FERC Project No. 2720-045

**Subject: Sturgeon Falls Hydroelectric Project (No. 2720) – Exhibit A Revision and Nameplate Update**

**Revised Exhibit A.    Clean Copy**

## Unit #1 Turbine Nameplate

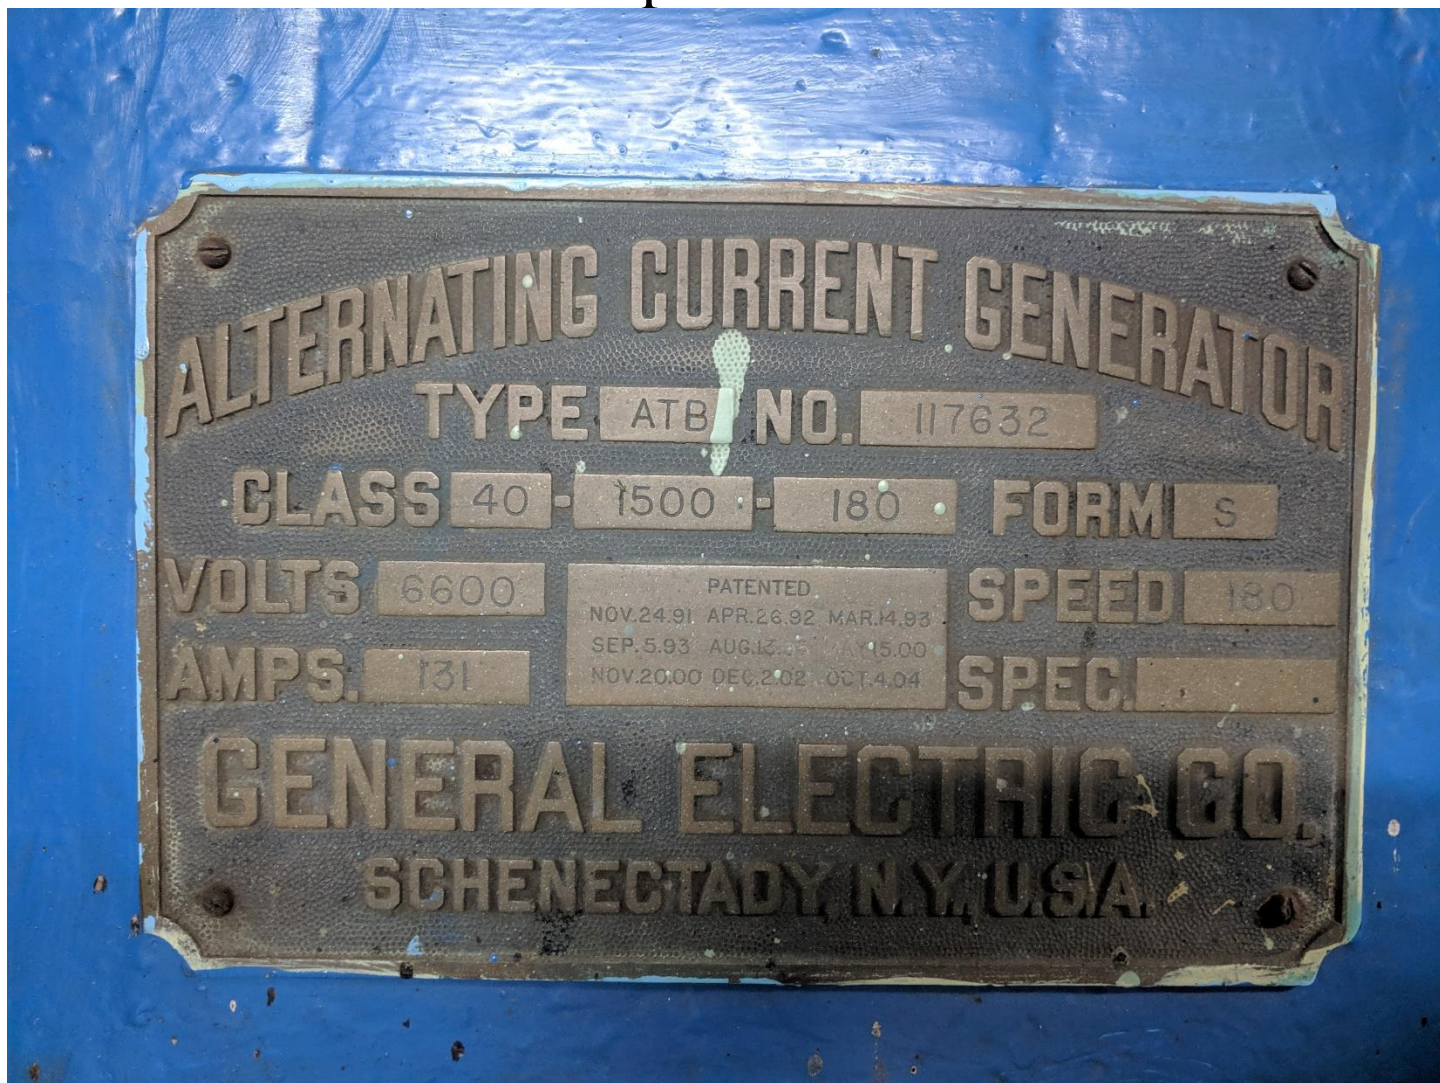
In 2019, after the turbine runner replacement for Unit #1, the unit was placed in service with an updated capacity of 2,960 kW on November 1, 2019. The enclosed Revised Exhibit A reflects the changes resulting from the 2019 turbine replacement project.

Pictures of the corrected generator nameplates and the turbine nameplates for Turbine Units #1 and #2 are also enclosed in the Revised Exhibit A. Unfortunately, without knowing a new nameplate was in its possession for Turbine Unit #2, the June 7, 2019 filing inadvertently underreported the capacity of Unit #1 as 1,468 kW by reporting the information provided by the installation contractor. With the new turbine runners installed for Unit #2 in 2018, the rating is 1,480 kW according to the nameplate for the new turbine runners. The enclosed Revised Exhibit A has also been updated to reflect the correct capacity of Unit #2 that was placed in service on December 16, 2018.

As of November 1, 2019, the capacity of Unit #1 is 2,960 kW and the total capacity of the hydroelectric project is 6,440 kW as outlined in the enclosed revised Exhibit A.

## Unit #2 Turbine Nameplate

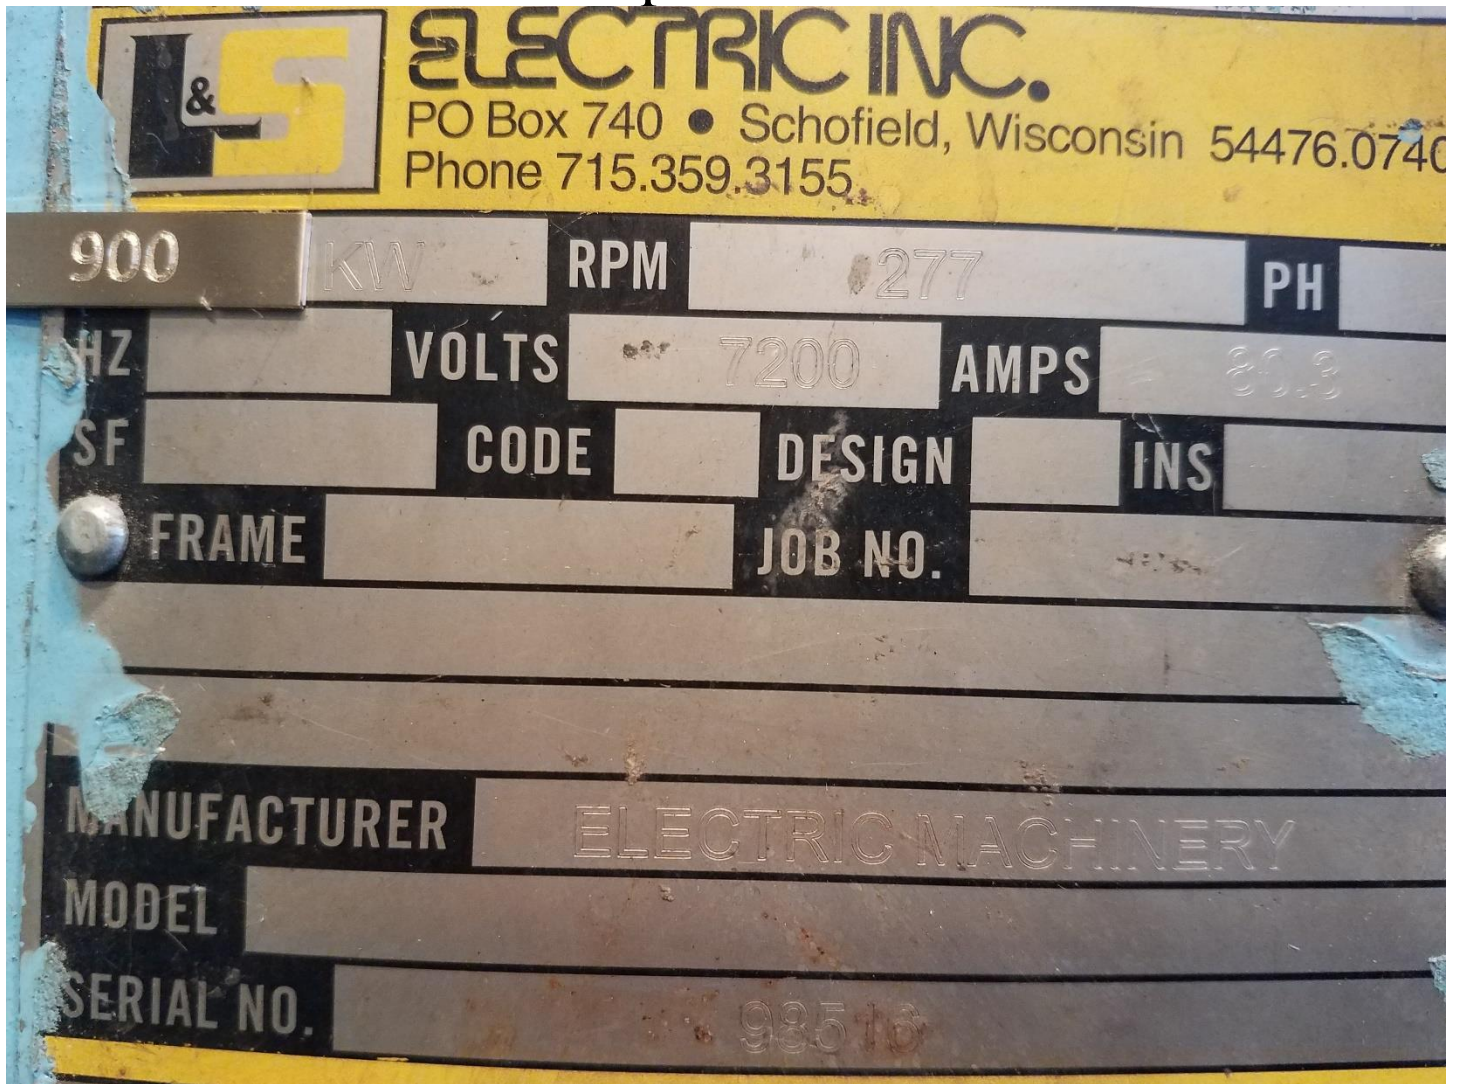
We apologize for any inconvenience the Turbine Unit #2 nameplate oversight may have caused.
